INTRODUCTION

Chrysler A604

CHRYSLER A604 NEW 4 RING STATOR

Figure 1

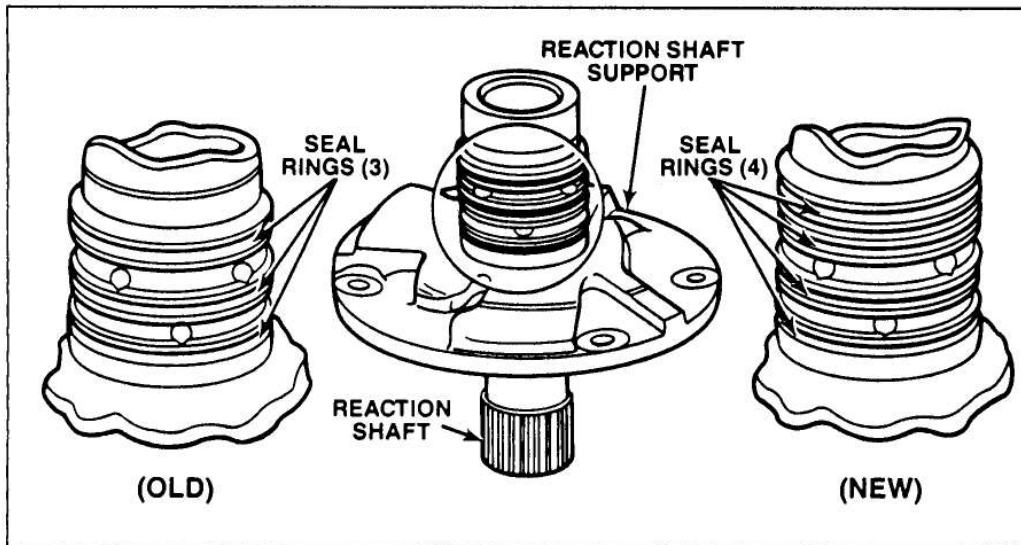
CHANGE: Beginning in April, 1989 a new Reaction Shaft Support (Stator) was introduced, with the addition of another ring groove and sealing ring. The old support has 3 sealing rings, and the new support has 4 sealing rings (See Figure 1).

- (1) REACTION SHAFT SUPPORT - The new support is longer, and has 4 sealing rings, where the old support only has three (See Figure 1).
- (2) INPUT SHAFT/CLUTCH HUB - The new Input Clutch Hub bore is machined deeper to accommodate the additional length of the reaction shaft, created by the added sealing ring (See Figure 2).
The "O" Ring grooves are also cut shallower than the old input clutch hub, which increases the groove diameter, and provides improved compression or "Crush", between the "O" rings and the input clutch retainer. (See Figure 2).

Figure 2

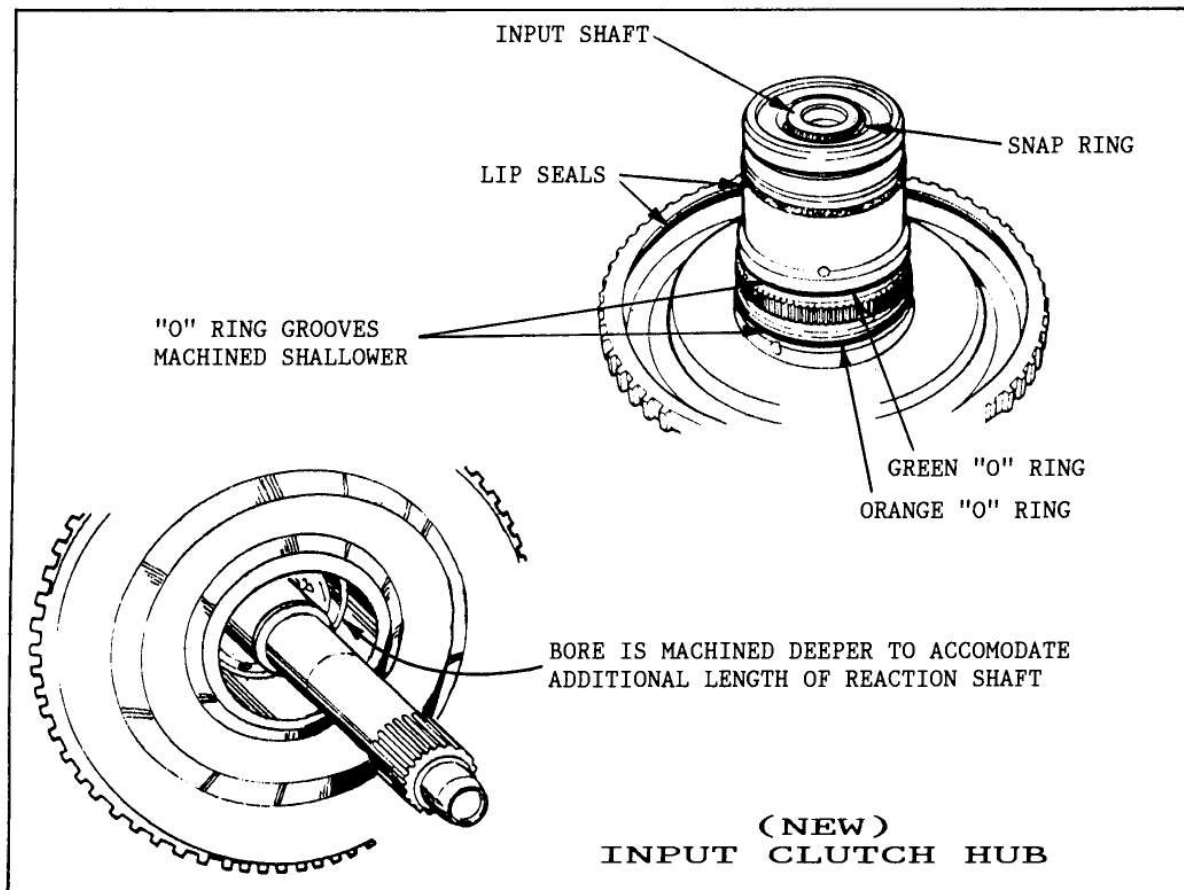
- (3) INPUT SHAFT/CLUTCH HUB "O" RINGS - The new "O" Rings are "Teflon Coated" for greater tear resistance during the assembly process. The coatings also identify the locations for the "O" Rings. The orange ring goes to the front, and the green one goes to the rear (See Figure 2). The early "O" rings were black.

Figure 3

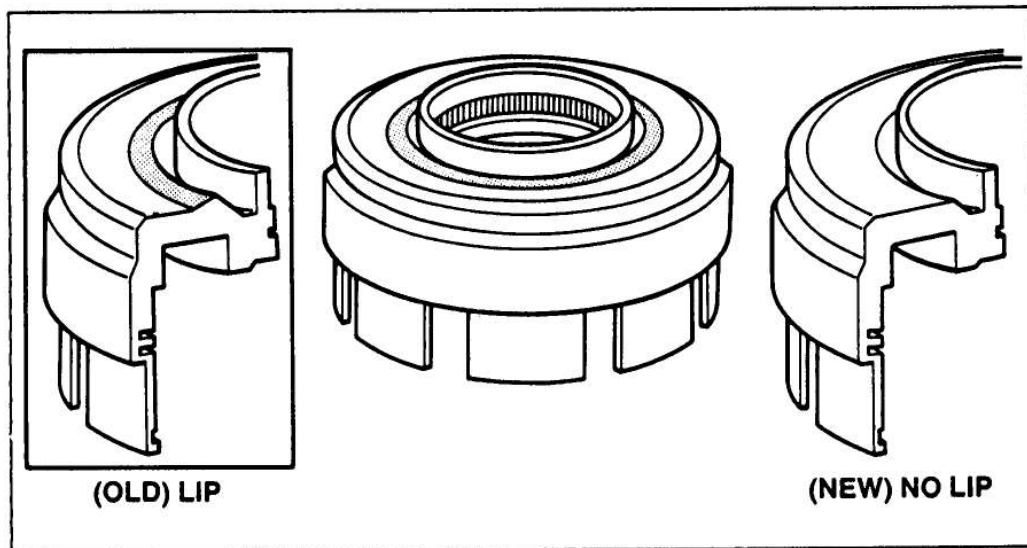
- (4) INPUT CLUTCH RETAINER - The Input Clutch Retainer was modified, by machining off the "Lip" (See Figure 3), to allow more travel of the overdrive/reverse piston. The old Input Clutch Retainer can be machined at the local machine shop if necessary.

Figure 4

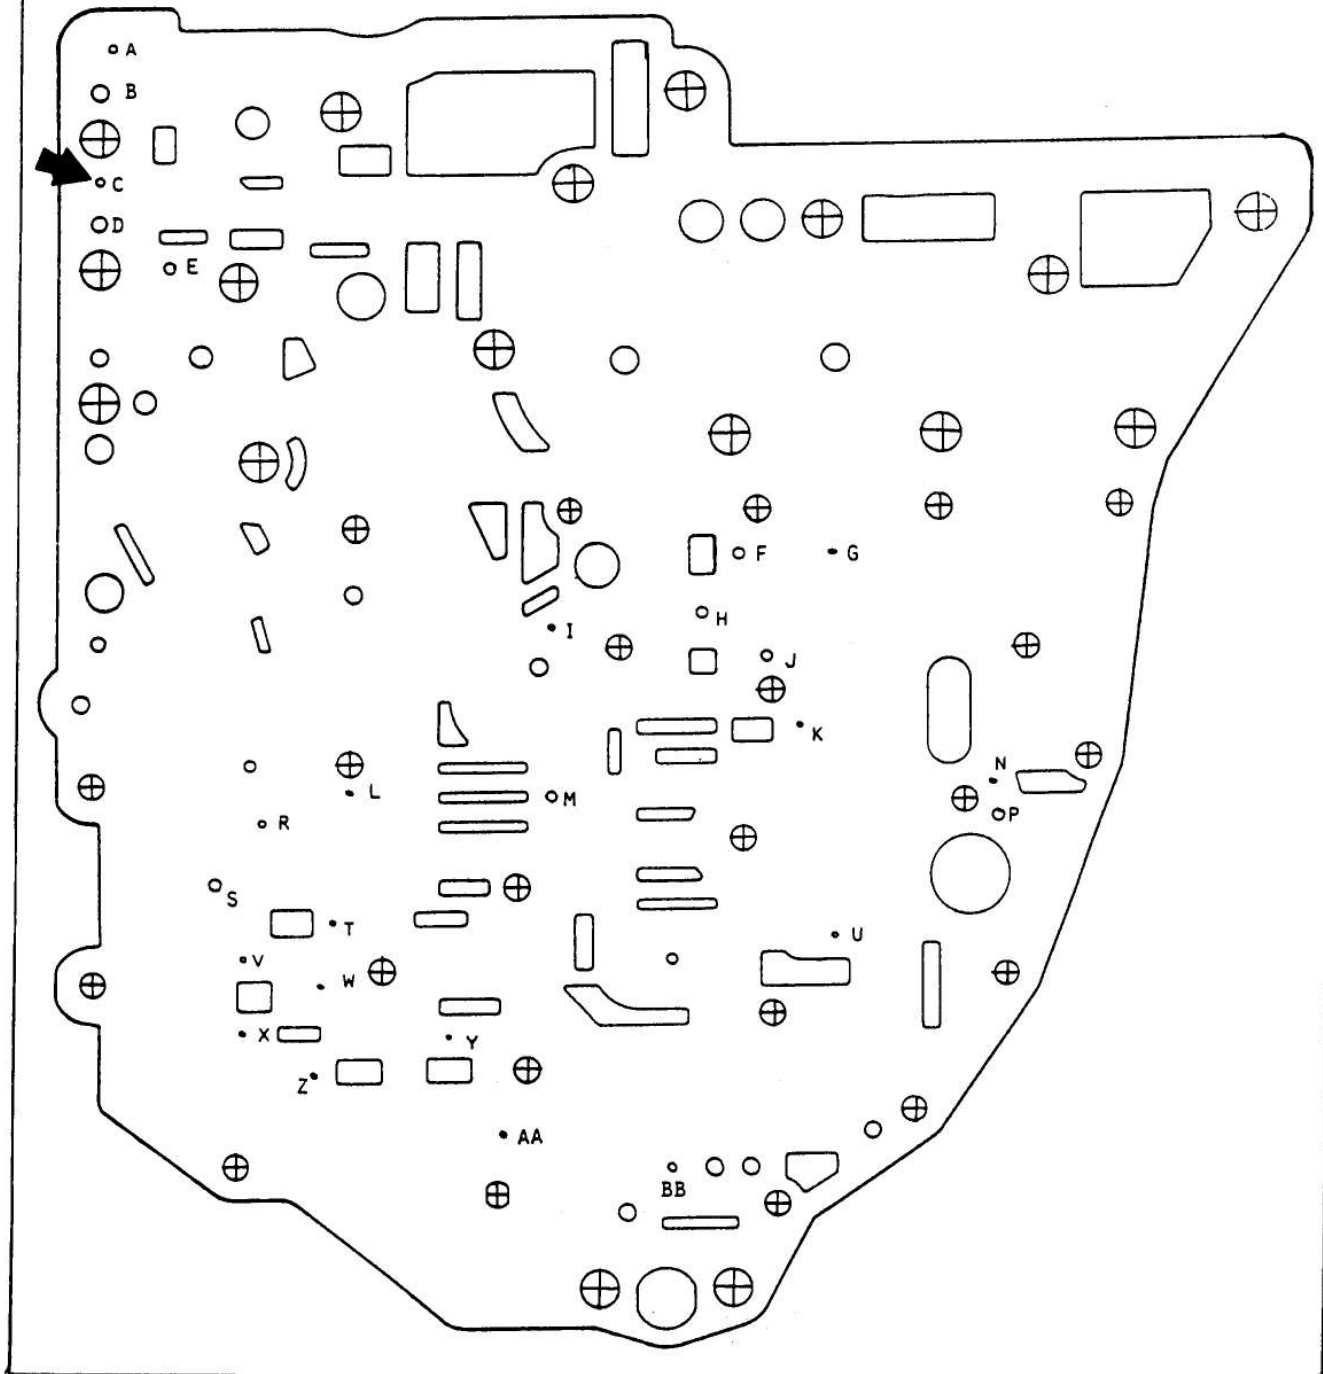
- (5) SPACER PLATE - The new Spacer Plate has a larger (.105") overdrive clutch feed orifice to provide increased oil flow to the overdrive clutch circuit (See Figure 4).

HOLE "C" ENLARGED TO .105" FOR INCREASED OIL FLOW

Figure 5

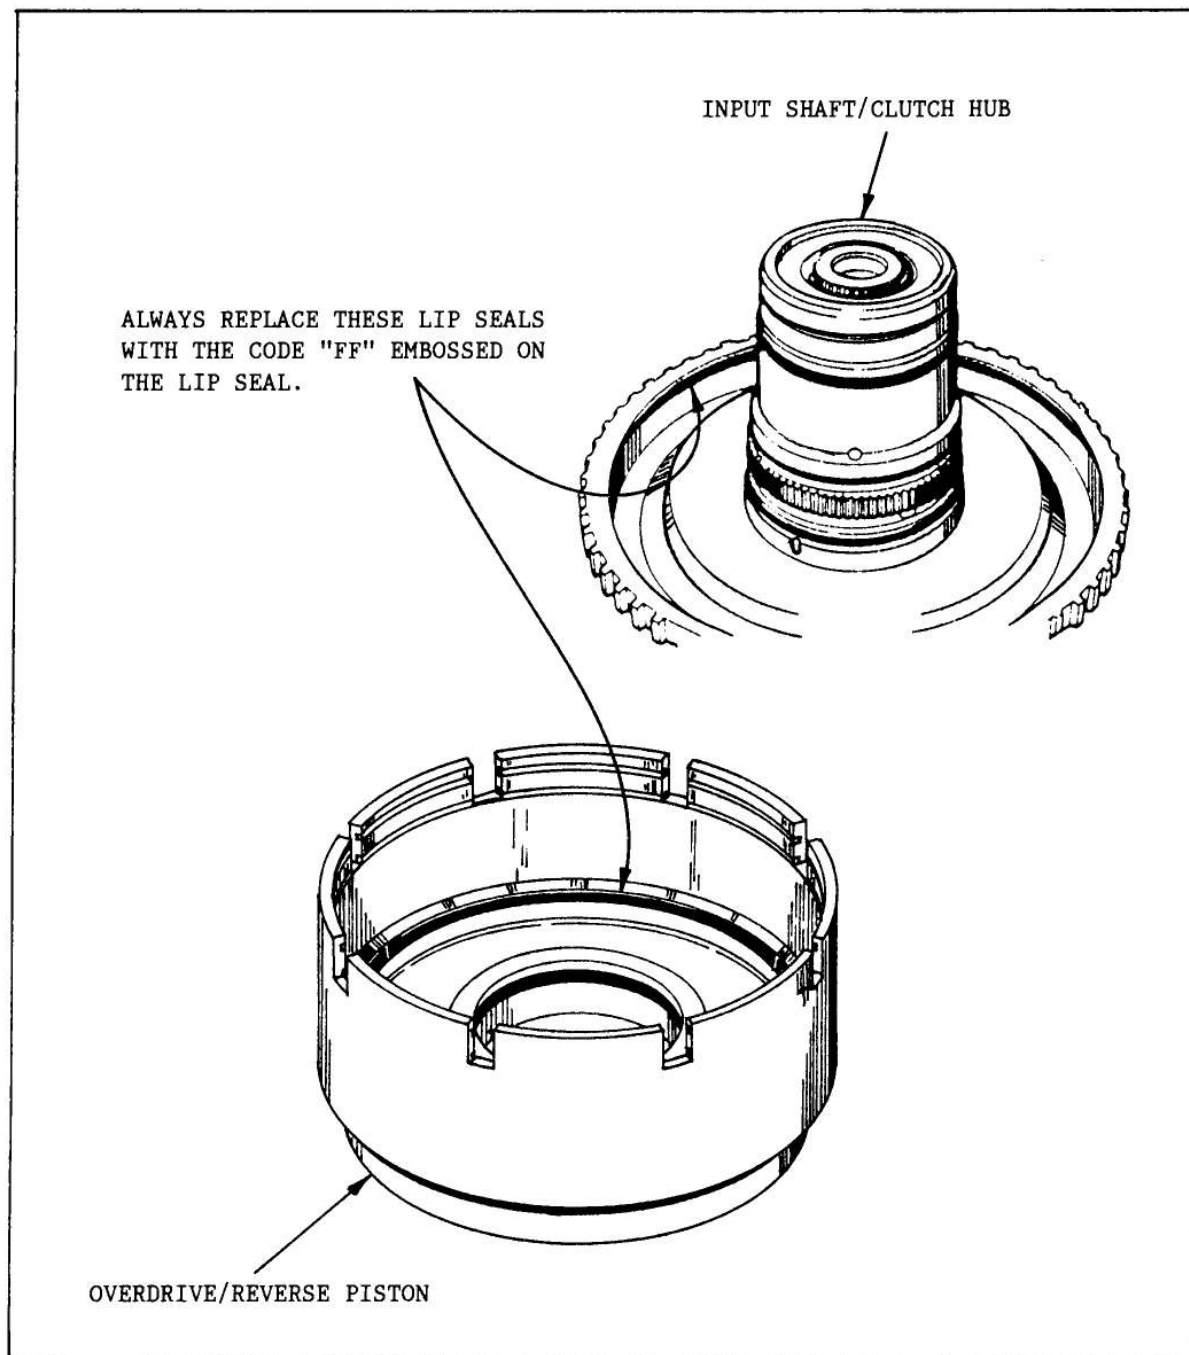
CHANGE: The lip seals in the Overdrive/Reverse Clutch Piston and the Input Shaft/Clutch Hub are now replaced with lip seals made of different material (See Figure 5).

- (1) OD/REVERSE PISTON LIP SEAL - No dimensional changes, but the material changes, and the new lip seals can be identified by the code "FF" embossed into the seal. The old lip seal is embossed with the code "IPC", and should not be used (See Figure 5).
- (2) INPUT CLUTCH HUB OUTER LIP SEAL - No dimensional changes, but the material changes, and the new lip seals can be identified by the code "FF" embossed into the seal. The old lip seal is embossed with the code "IPC", and should not be used (See Figure 5).

THE NEW LIP SEALS EMBOSSED WITH THE CODE "FF" WILL RETRO-FIT BACK TO ALL PREVIOUS MODELS, AND SHOULD BE USED DURING OVERHAUL.

Figure 6

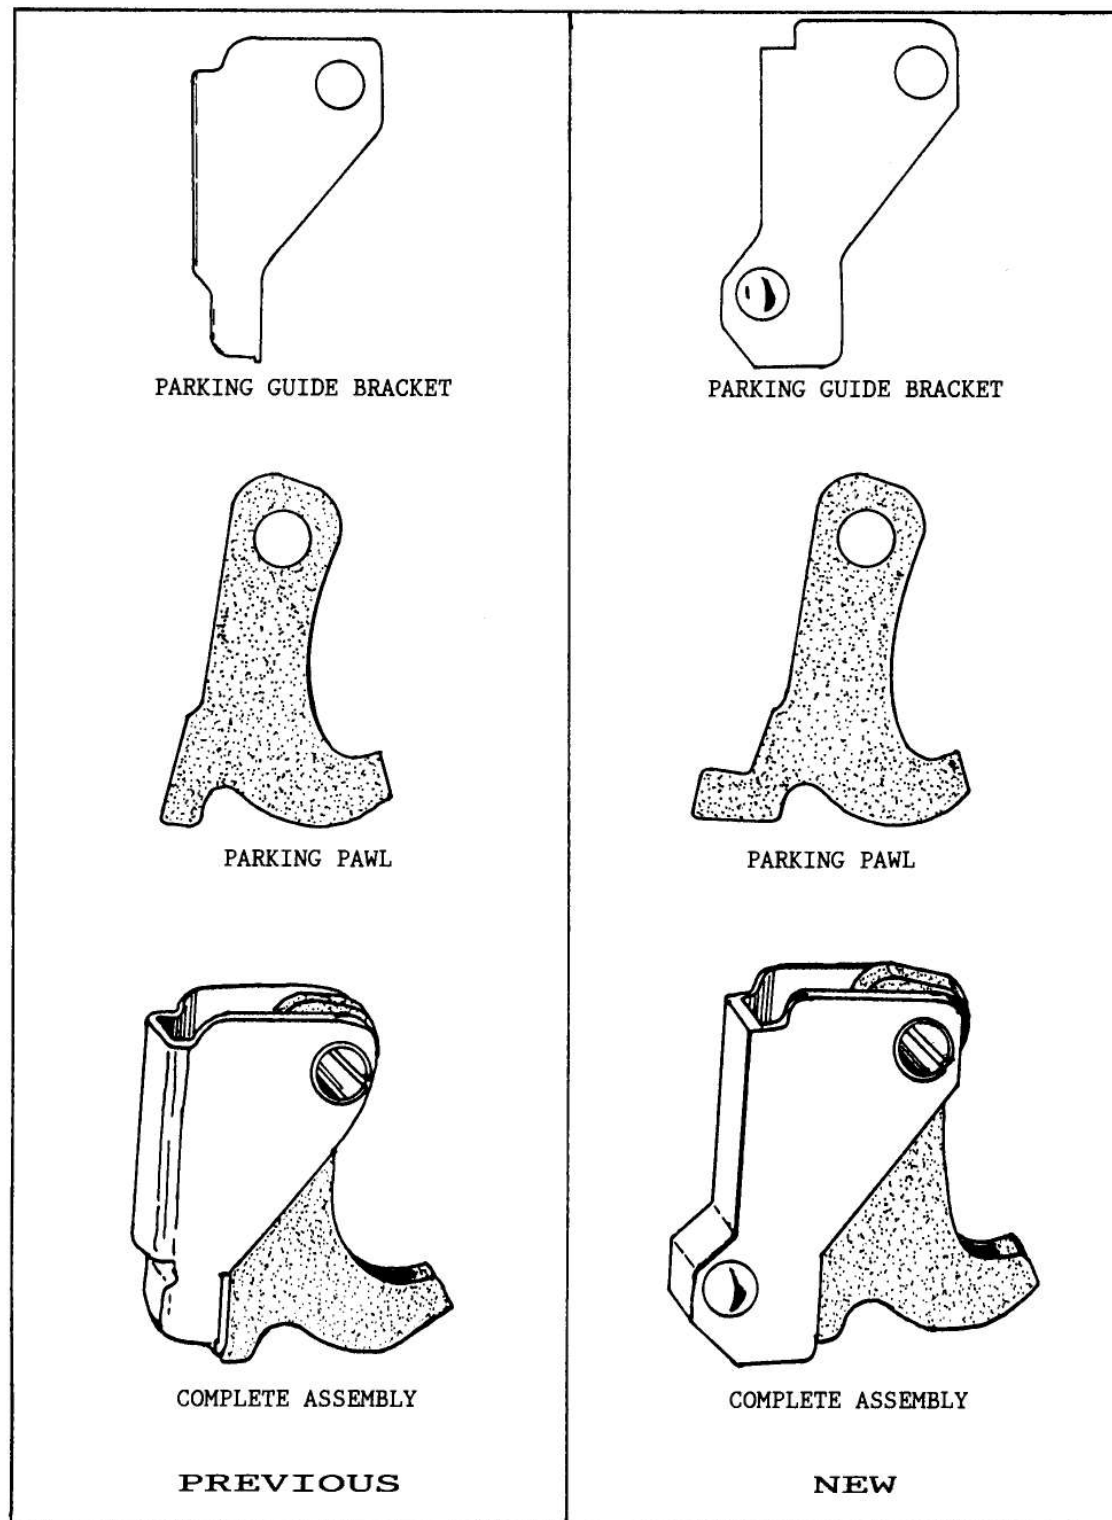
CHANGE: A new Parking Sprag Guide Bracket and Parking Pawl has been introduced as a 1989 running change (See Figure 6).

- (1) **PARKING GUIDE BRACKET** - Previously the Parking Guide Bracket was a stamped steel unit, and has been replaced by a high quality casting, along with dimensional changes. See Figure 6 for identification.
- (2) **PARKING PAWL** - The new Parking Pawl, or "Boot", also required some dimensional changes. The heel of the new "Boot" is wider than the previous models, as shown in Figure 6.

The new parts will retro-fit back to all previous models, but both pieces must be replaced as an assembly. (See Figure 6).

Figure 13

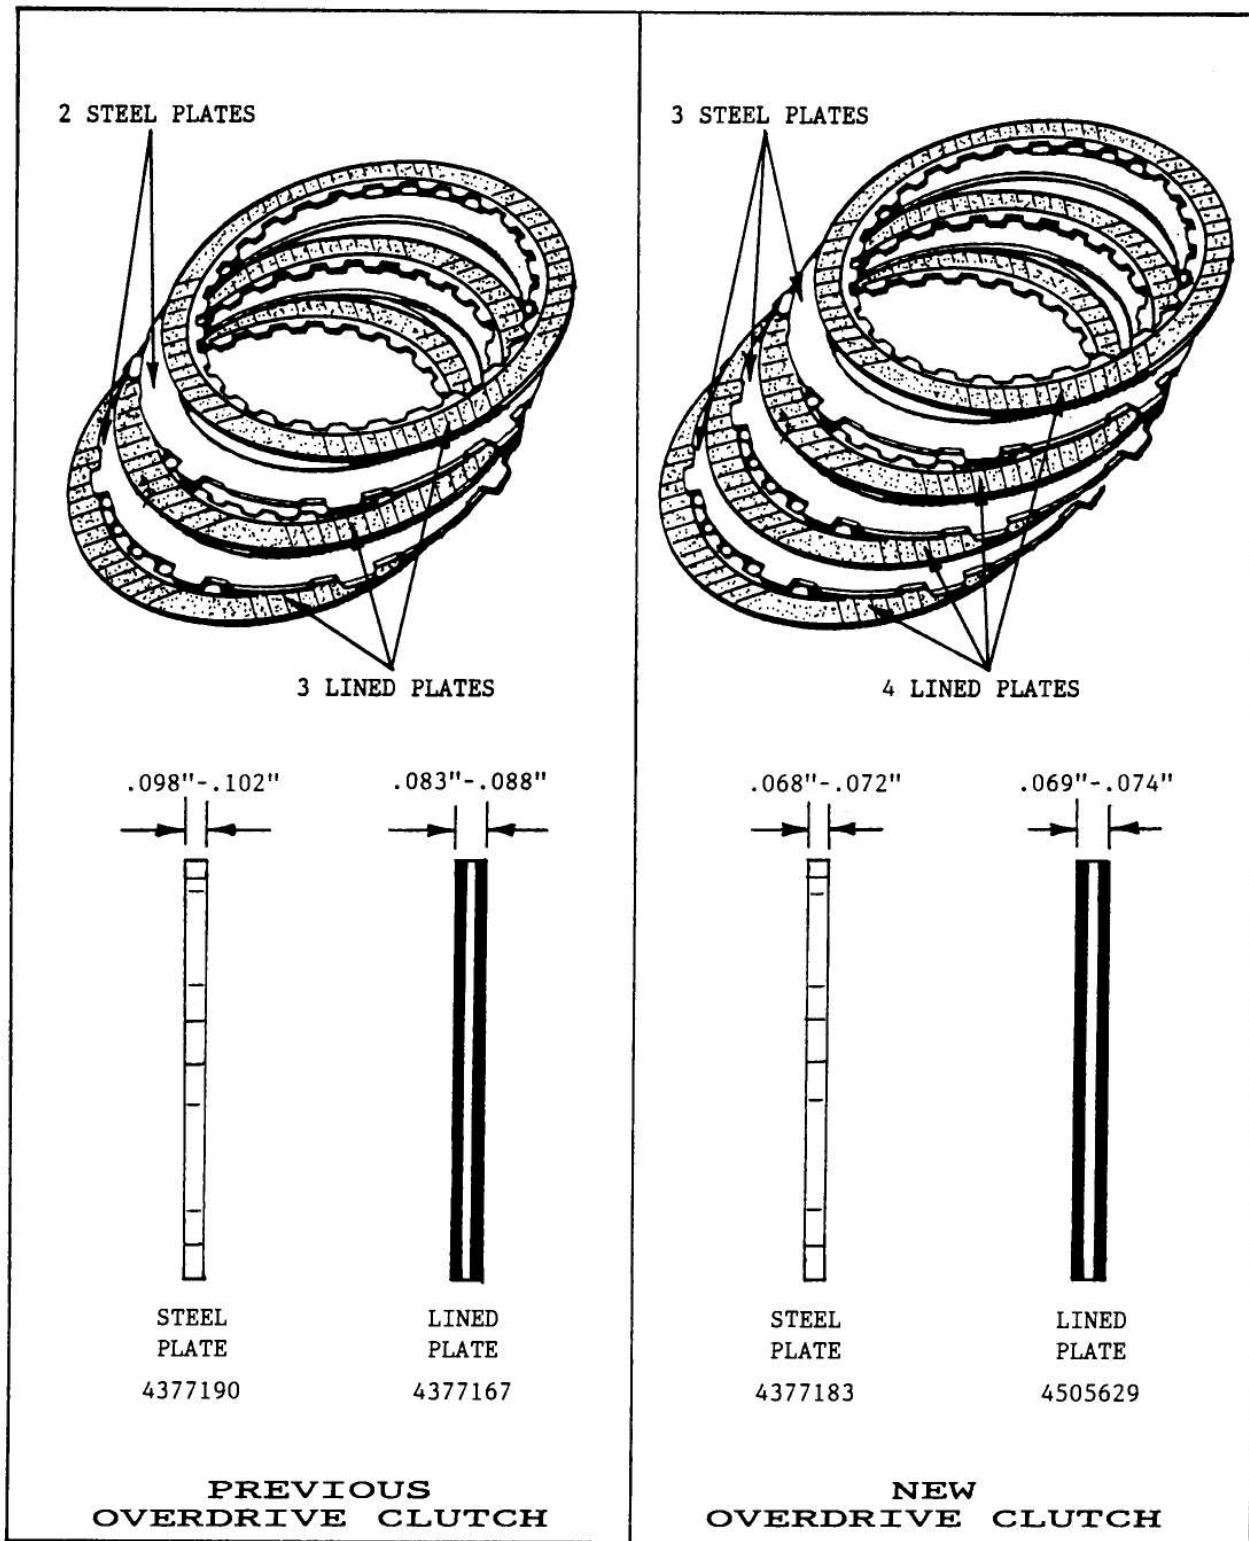
CHANGE: A running change for 1990 model A604 transaxles was the introduction of a four (4) disc Overdrive Clutch Assembly, to replace the previous three (3) disc assembly (See Figure 13).

- (1) OVERDRIVE LINED PLATES - Now uses 4 lined plates instead of the previous 3 lined plates, and the lined plates for 1990 models are .014" thinner than the 1989 lined plates (See Figure 13), to help accomodate the extra lined plate. The 1989 lined plates will measure .083"-.088" thick, and the new lined plates will measure .069"-.074" thick (See Figure 13).

- (2) OVERDRIVE STEEL PLATES - Now uses 3 steel plates instead of the previous 2 steel plates. The new steel plates are .030" thinner, and measure .068"-.072" thick. The previous steel plates measure .098"-.102" thick. (See Figure 13).

Figure 14

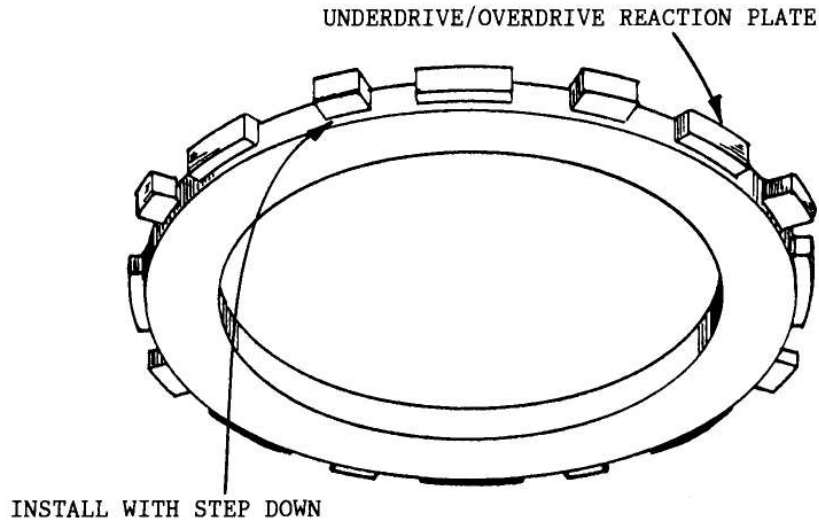
- (3) UNDERDRIVE/OVERDRIVE REACTION PLATES - The 1989 Underdrive/Overdrive Reaction Plates have always been available in 4 different thicknesses to obtain proper clutch clearance. For 1990, each plate was reduced in thickness by .040", to help accomodate the extra overdrive plates. (See Figure 14).

FOR 1990, EACH REACTION PLATE WAS REDUCED IN THICKNESS BY .040", TO ACCOMMODATE THE EXTRA OVERDRIVE PLATES.
